## Letter of Submittal and Compliance

RE: FCC ID: LL9MP200V Grantee: Sierra Wireless Inc.  
Equipment Class: Non-Broadcast Transmitter  
Application for Class II Permissive Change dated December 21, 1999

## Expository Changes (2.1001(b)(2))

Figure 1: TCXO Interface Circuits

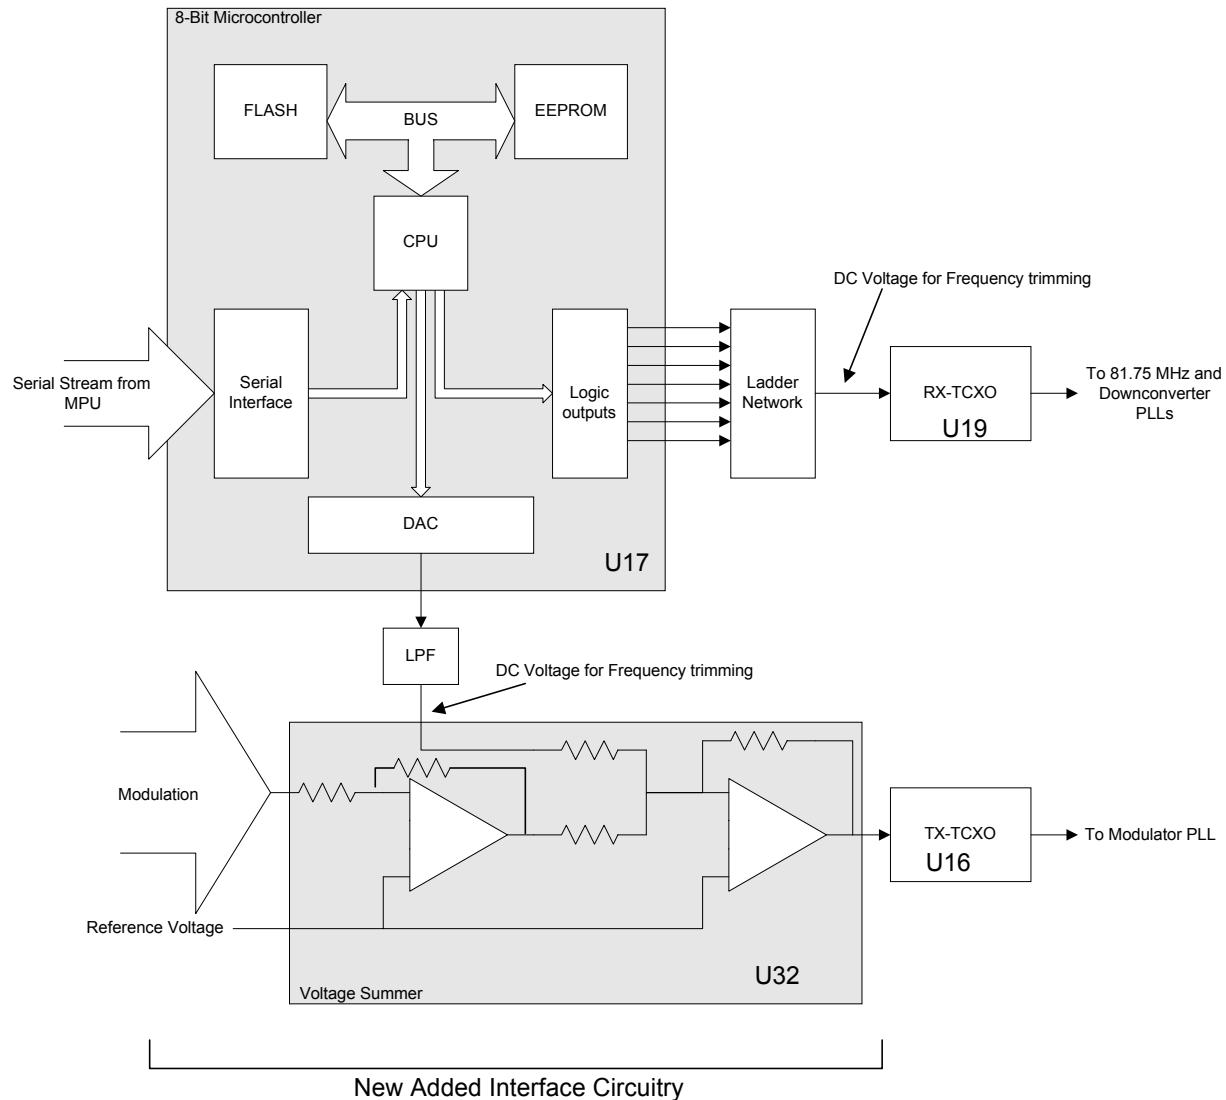
The RX and TX Temperature Voltage Controlled Crystal Oscillators (TCXOs) have been replaced. Figure 1 shows the circuitry newly implemented.

The obsolete crystal oscillators have integrated logic and EEPROM that support a serial link with the Main Processing Unit (MPU) of the modem, two Digital to Analog Converters (DACs) as well as a calibration look-up table. During the initial factory calibration process, the CPU sends serial streams to the RX and TX TCXOs with incrementing calibration values. When the generated RF frequency error is minimum, the MPU sends a command so the current calibration value is written onto the EEPROM. Because the replacing parts do not integrate logic circuits, we have added an 8-Bit microcontroller. Figure 1 shows the diagram of the circuitry newly implemented. The microcontroller's main functions are to read calibration values on EEPROM, to receive and process the commands going to the serial interface, to implement a DAC, and to control logic outputs, these one being part of a ladder network DAC. The DAC and Ladder Network are two DACs that allow control of the DC voltage at the voltage control input of the two TCXOs. Since the baseband signal modulates the TX-TCXO, a summer made of operational amplifiers combines the frequency adjust DAC voltage output and the information signal.

As is explained in the previous sub-section, the modulation signal path is slightly changed. Indeed, the op-amp configuration replaces the internal circuitry that was implemented in the previous TX-TCXO (see figure 1). However, the high port path remains unchanged. Changes affect only the low frequency range (below 300Hz of the signal, which is the approximate cutoff frequency of the loop filter).
